Chip Errata
DSP56156 Digital Signal Processor
 Mask: D89T

ERRATA

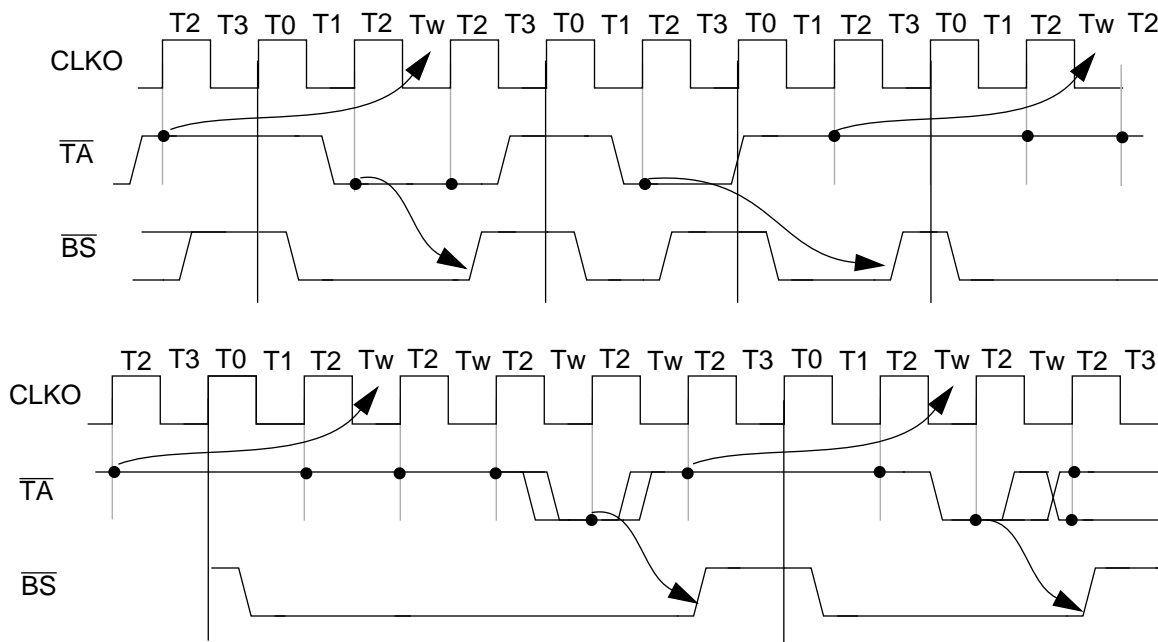
2. The OnCE pins OS1 and OS0 will not display the status of the chip correctly when in the wait condition (executing wait states because the current bus cycle hasn't completed due to \overline{BG} or \overline{TA}).
